TENNESSEE VALLEY AUTHORITY

Please refer to J. A. Domer's letter to you dated January 16, 1986 concerning a fifth vital battery system presently being installed at Watts Bar Nuclear Plant. Enclosed for your review are marked-up changes to the FSAR describing the fifth vital battery system.

Fifth Vital Battery FSAR Revision

Figures: 8.1-3 (R5), 8.3-2 (R6), 8.3-39 (R17), 8.3-40 (R16), 8.3-47 (R18),
8.3-48 (R19), 8.3-49 (R17), 8.3-50 (R15), 8.3-56 (R1), 8.3-57 (R3)

WATTS BAR NUCLEAR PLANT
FINAL SAFETY
ANALYSIS REPORT
AUXILIARY BUILDING
UNITS 1 & 2
ELECTRICAL EQUIPMENT
125V VITAL BATTERY V-EL 772.0
PLANS & DETAILS
TVA DRAWING NO. 45W217-1 R3
FIGURE 8.3-57

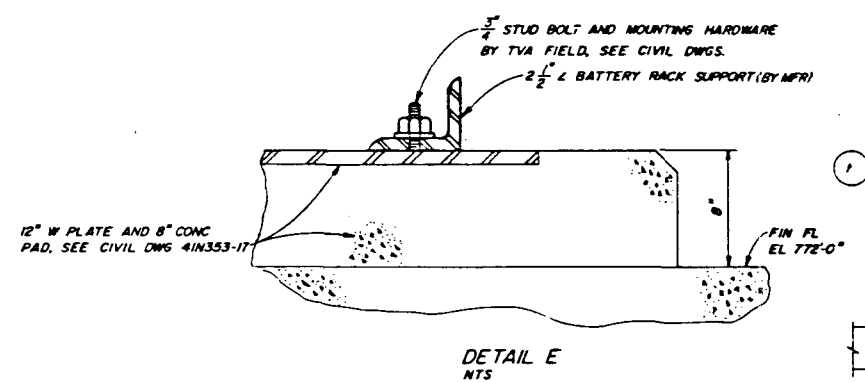
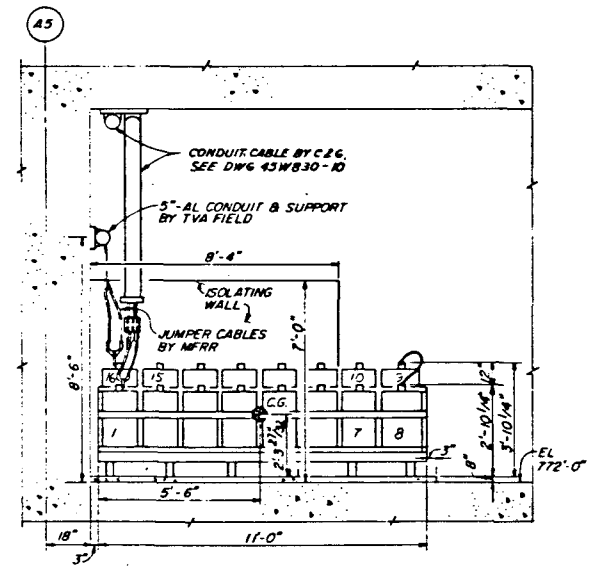
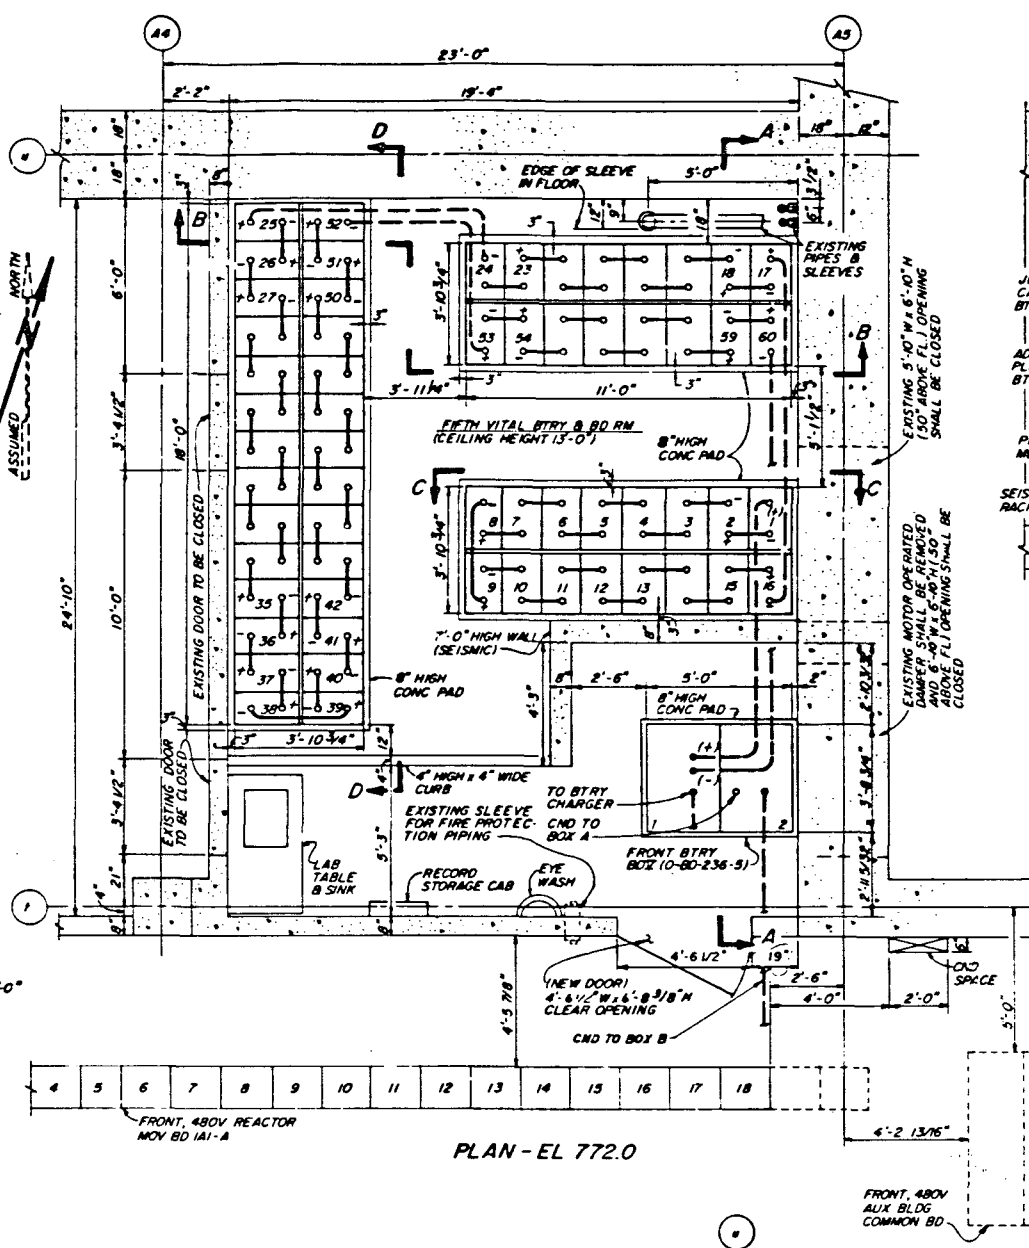
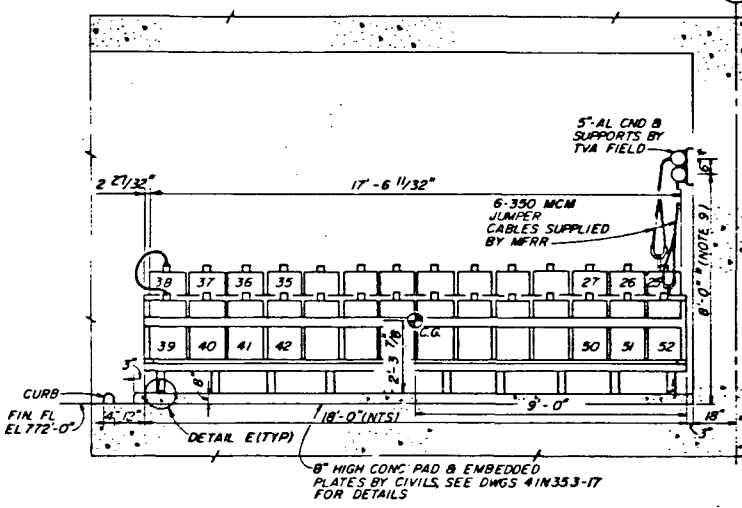
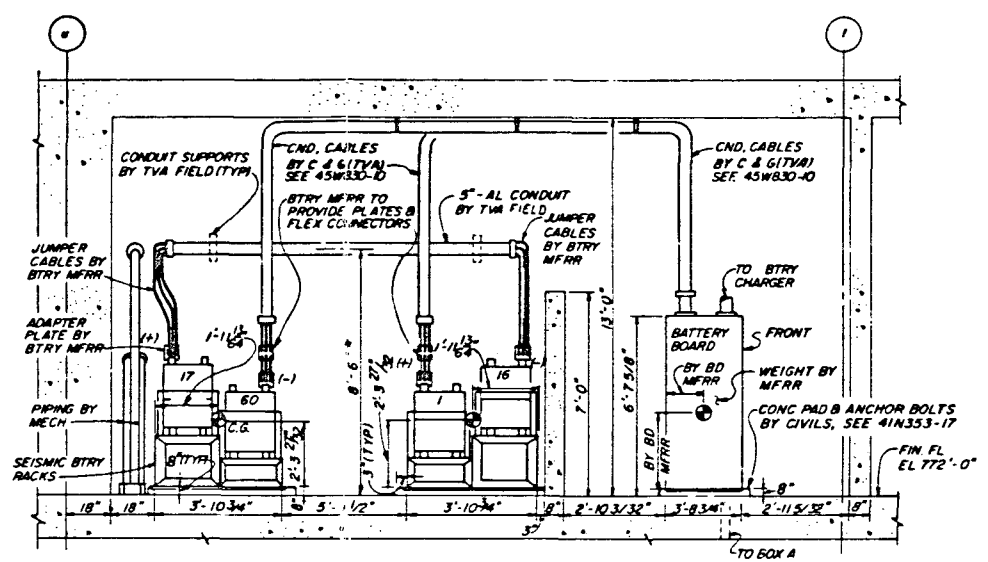
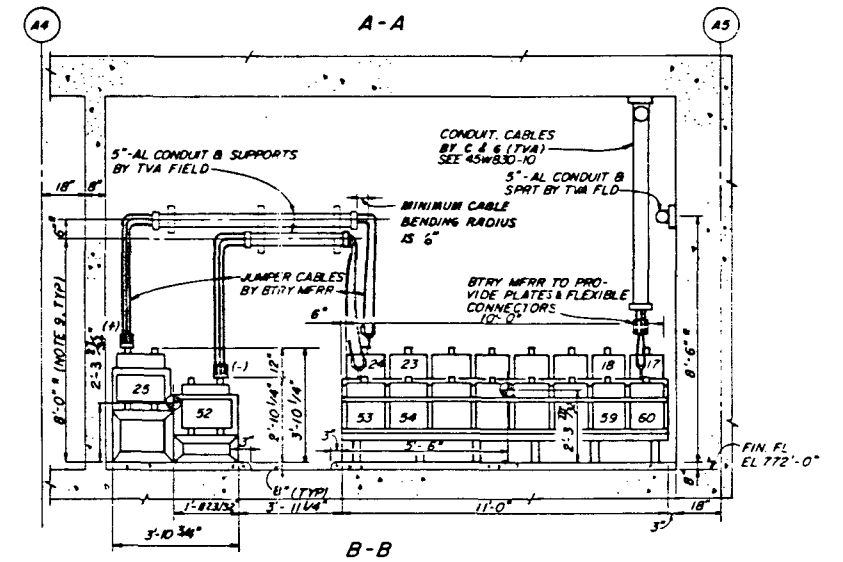
Vital battery board V is located on elevation 772 in the same room as vital battery V and is separated from the battery by a 7 ft. high, 8 in. thick seismic wall (figure 8.3-57).

Reference: Figures 8.3-36 and 8.3-57

Reference: Figures 8.3-36 and 8.3-57

WATTS BAR NUCLEAR PLANT
FINAL SAFETY
ANALYSIS REPORT
POWERHOUSE
UNITS 1 & 2
WIRING DIAGRAMS
125V VITAL BATTERY BD V
SINGLE LINE-SHEET 9
TVA DRAWING NO. 45W703-9 R1
FIGURE 8.3-56

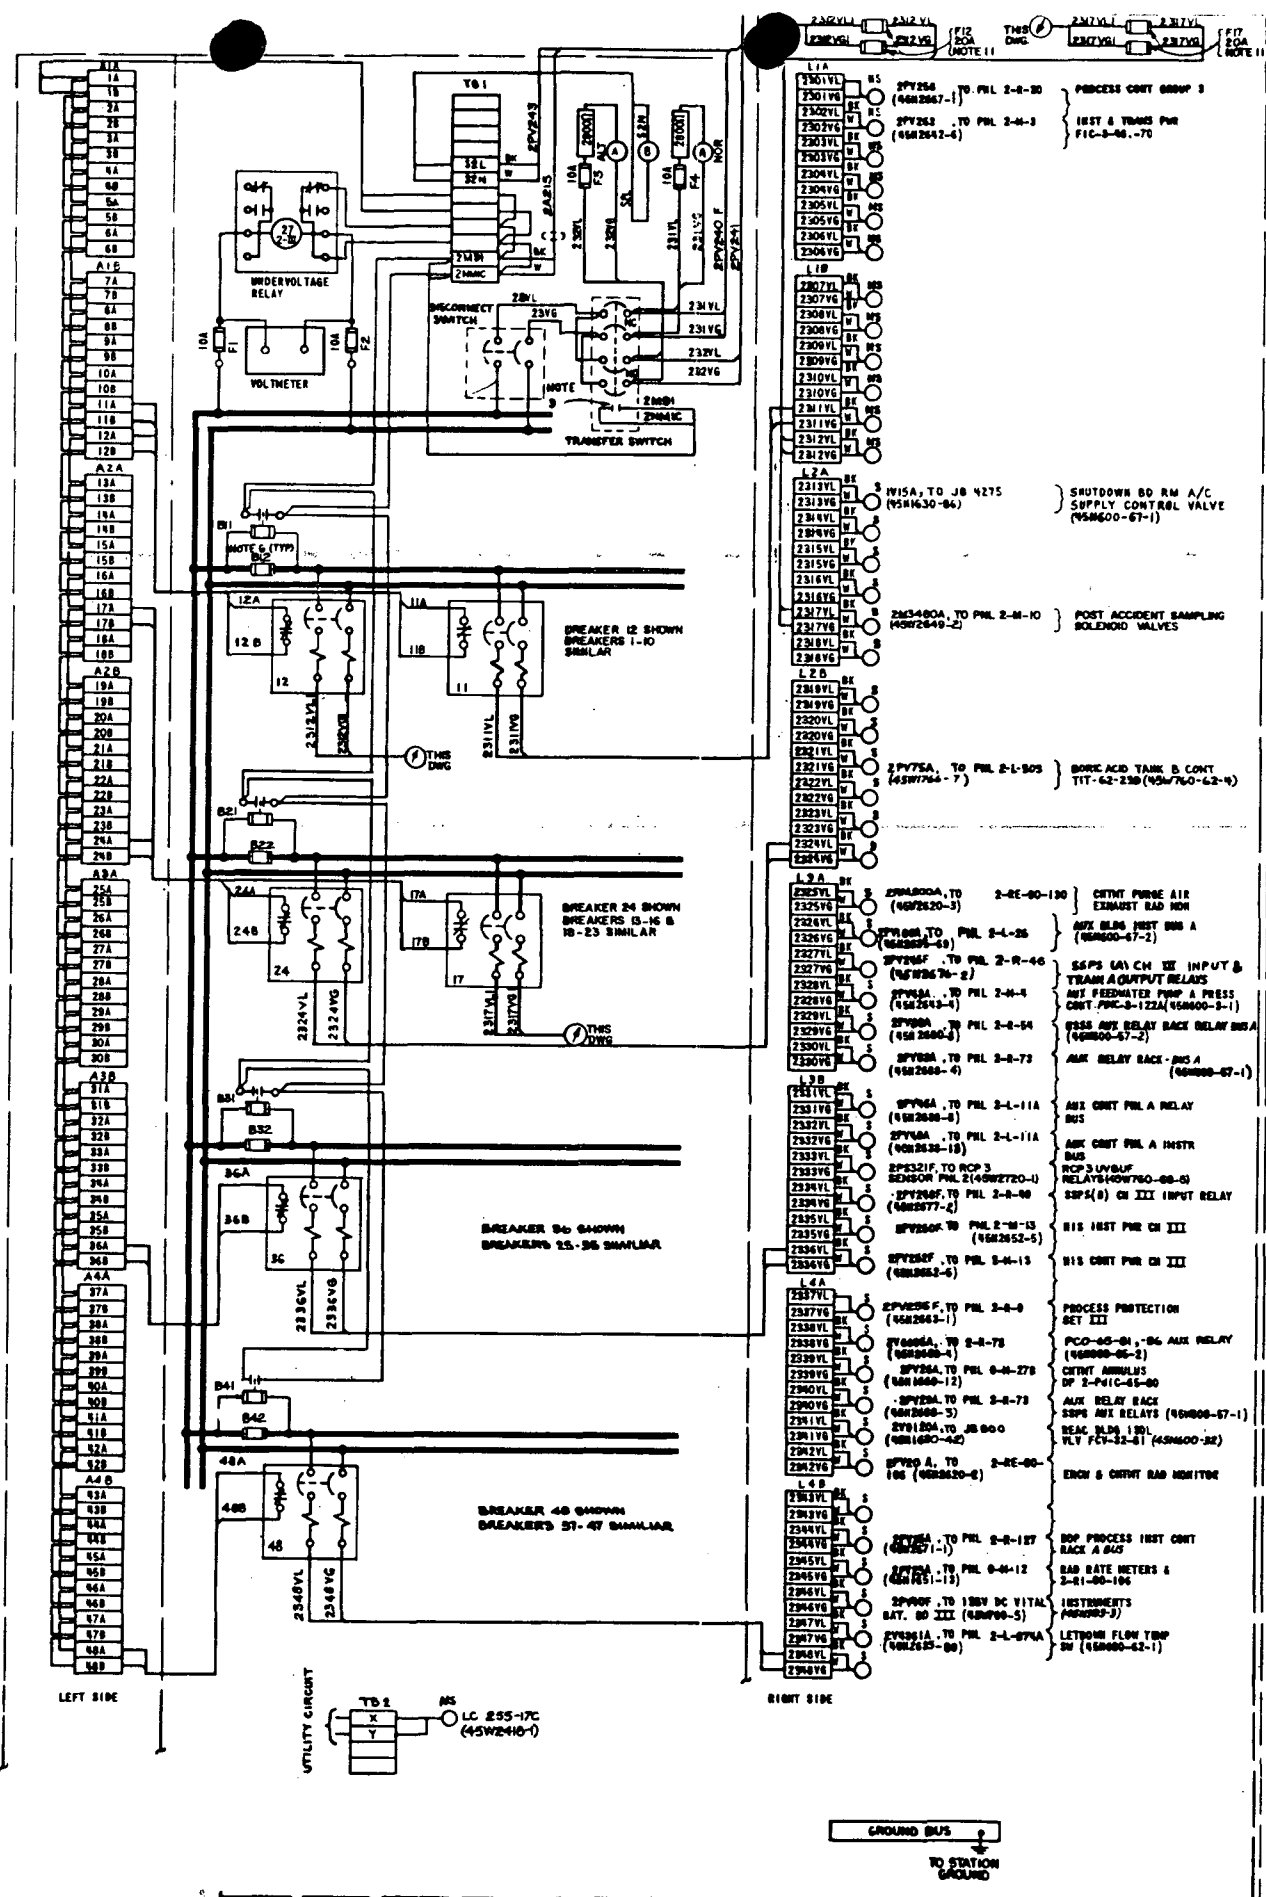
The fifth 125 V Vital Battery System is intended to serve as a temporary replacement for any one of the four 125-V dc vital batteries during their testing, maintenance, and outages with no loss of system reliability under any mode of operation. See figure 8.3-56

and figure 8.3-56

POWERHOUSE UNITS 1 & 2
 KEY DIAGRAM
 120V AC & 125V DC VITAL PLANT
 CONTROL POWER SYSTEM
 TVA DWG NO. 45N700-1 RS
 FIGURE 8.1-3

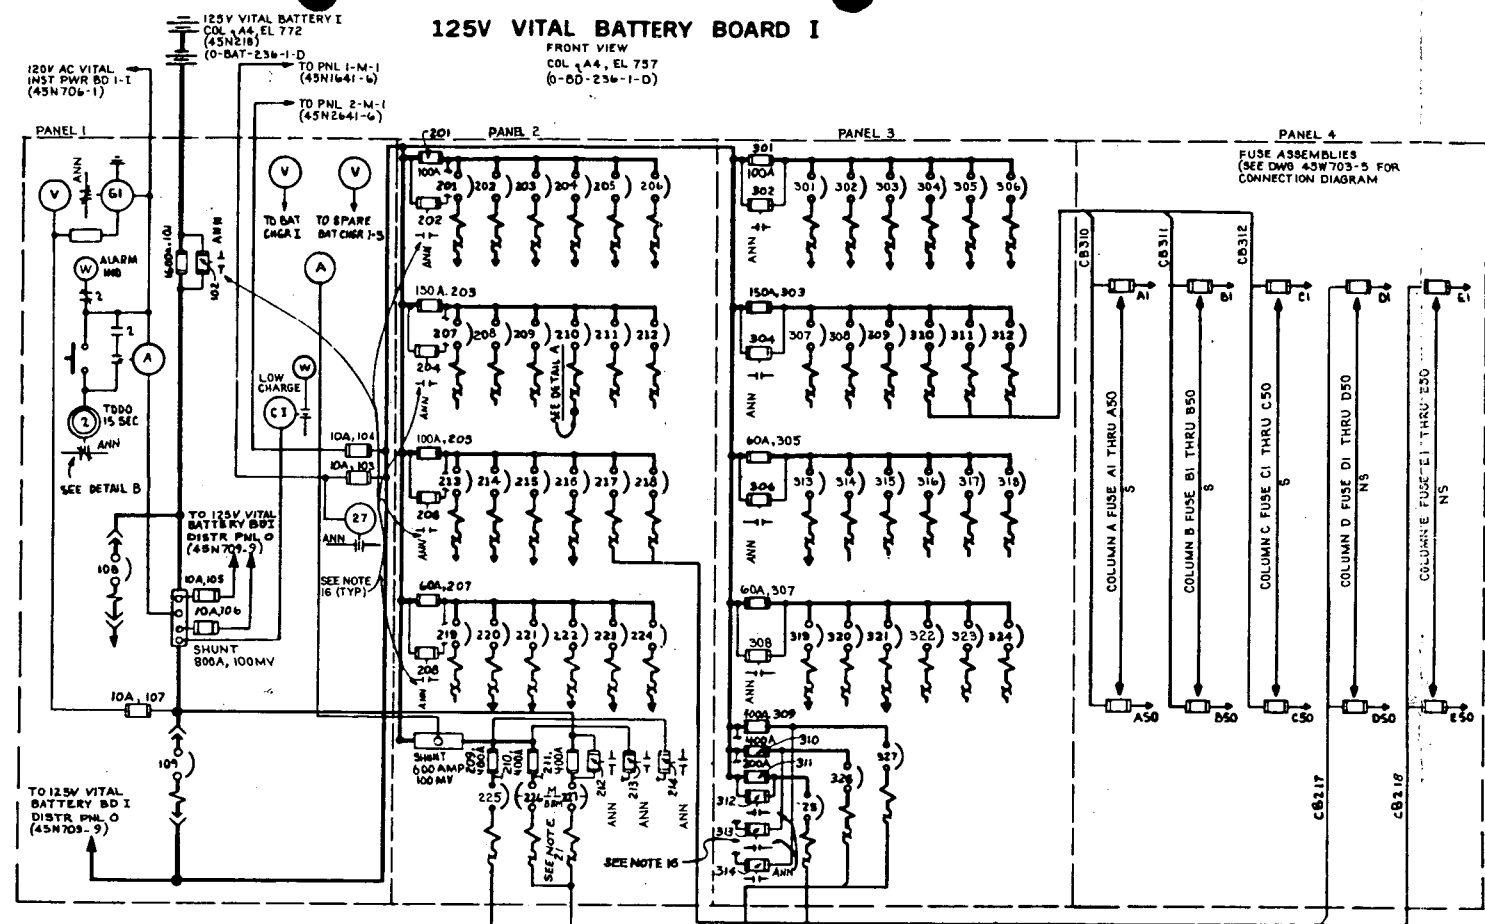
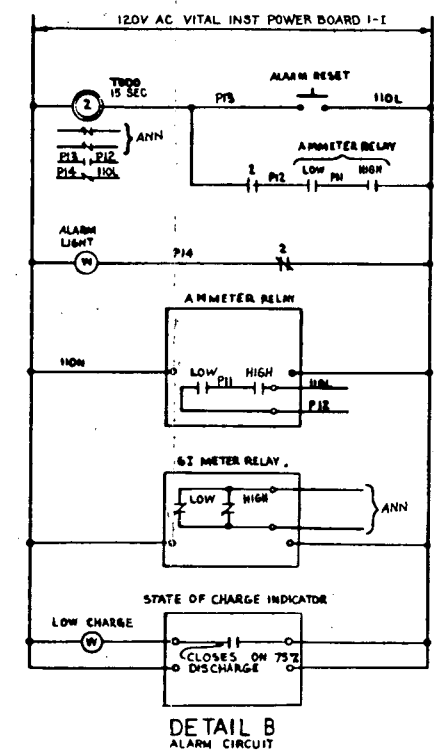
Referring to Figure 8.1-3, it can be seen that each of the three groups of loads are supplied from the main bus through a fuse to a stub bus from which the power is delivered to each load circuit via a molded-case automatic circuit breaker. Each stub bus may supply one or more breakers. Figures 8.3-37 through 8.3-40 show the exact circuit distribution. Each breaker and fuse has a current interrupting rating greater than the maximum short-circuit current capability of the battery and charger combined. Each breaker and fuse is sized in accordance with circuit requirement. The interposing fuse between the main and stub buses not only provides high-speed clearing for a very severe close-in feeder fault, but it also provides redundant protection of the feeder in the event an
